# ERRATA SHEET

## 71M6533/71M6533G/71M6533H/71M6534/71M6534H

### Revision A05 Errata

Figure 1-1: 71M653x IC with External Capacitors

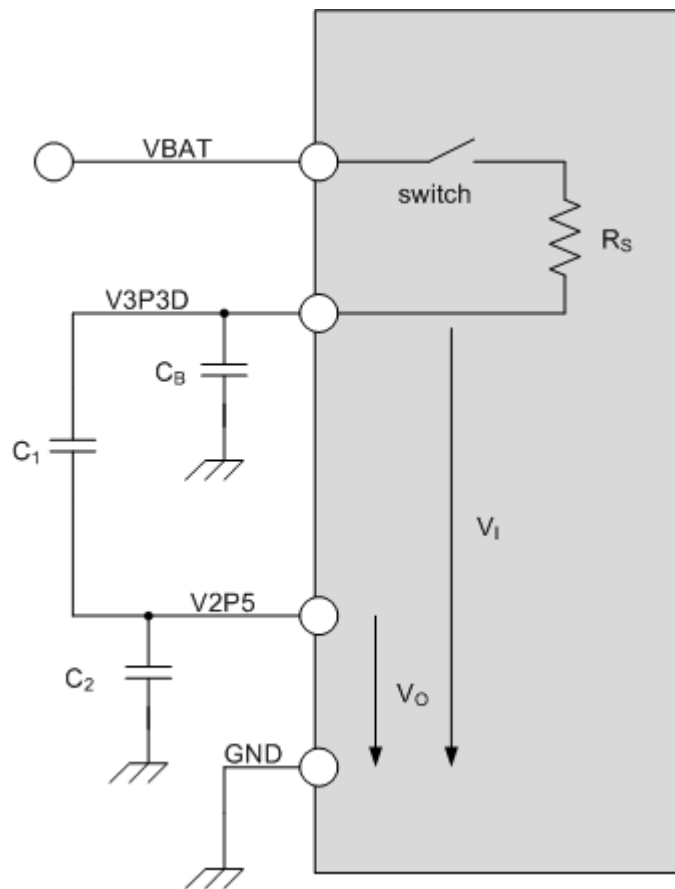
A small percentage of 71M653x ICs shows an anomaly when transitioning from SLEEP mode to BROWNOUT mode under the control of the wake-up timer: These parts can have unexpected and unwanted voltages on the LCD-related pins which can manifest itself as a temporary flicker of segments occurring for a few milliseconds before the MPU reestablishes proper initialization of the LCD system in BROWNOUT mode.

When transitioning from SLEEP mode to BROWNOUT mode via the wake-up timer feature, the LCD register reset signal becomes inactive at the same time the power to the registers is being restored. Part to part variation in addition to voltage and temperature can change this relationship. In some cases the reset may become inactive earlier than the supply power, which results in the power coming up too late to preserve reset at the LCD registers. When this happens the starting state of some segments will be indeterminate.

## CAPACITOR FROM V3P3D to V2P5:

This workaround might be a good choice where both the V3P3D pin and the V2P5 pin are easily accessible for soldering. A capacitor of nominally 61nF is recommended.

The conditions for the capacitor choice are as follows (see Figure 1-1):

- V2P5, when pulled up by the external capacitor, should be between 1.0V and 1.5V, but never above 2.75V.
- V2P5 is typically bypassed to GND with a 0.1 $\mu$ F capacitor.
- V3P3D can be between 3.0V (minimum voltage to maintain BROWNOUT mode) and 3.6V (maximum specified voltage).
- The internal load on V2P5 is minimal and can be neglected.
- The filter formed by the switch resistance  $R_S$  and the external capacitive load (100nF assumed) has a  $\tau$  of 8 $\mu$ s and can also be ignored for the purpose of this application.

The recommended value for the external capacitor  $C_1$  between V3P3D and V2P5 is based on nominal values of VBAT and V2P5, i.e., VBAT = V3P3D is assumed to be in between 3.0V and 3.6V (3.3V) and the target for V2P5 is midway between 1.0V and 1.5V (1.25V). Based on these values, the external capacitor  $C_1$  calculated as follows:

The choice of 61nF is acceptable considering deviations for  $C_2$  and VBAT. Since 61nF is not a standard choice for X7R capacitors,  $C_2$  can be increased to 68nF, which increases V2P5 for the minimal case calculated above and increases V2P5 in the maximum worst case to
